<b>T.I. no.:</b> 2025-15 <b>Updated:</b> -	<b>Topic:</b> ABS buffer in grounds container shaft
---	---

<b>Date:</b> 2025-11-03
<b>Affected machines:</b> SOUL 10/12
<b>From production date:</b> 10-25-2025
<b>From date:</b> right away

## NEW HOLDER FOR COMBINATION SENSOR AND NEW DEVICE BASE

Figure 1: ABS buffer 3370074789

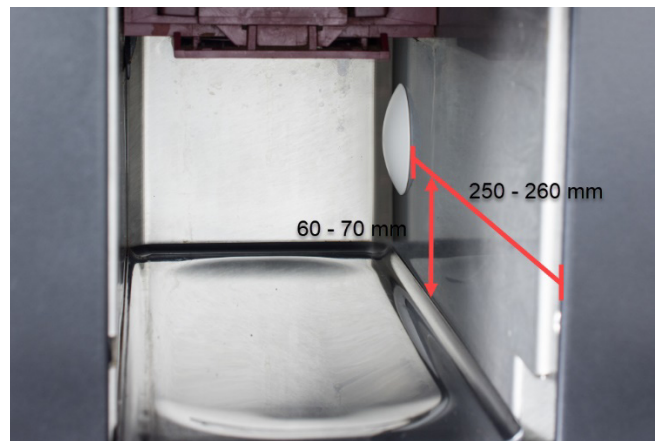
We are receiving an increasing amount of feedback that the grounds container is not detected correctly on some machines if it is positioned slightly too far to the right.

In this case, an ABS buffer (3370074789) must be attached to the rear right-hand side of the grounds container shaft. This pushes the grounds container slightly to the left so that it is correctly detected by the sensor.

- ▶ Clean the gluing point.
- ▶ Remove the protective film from the adhesive on the back and stick the buffer in the position shown.
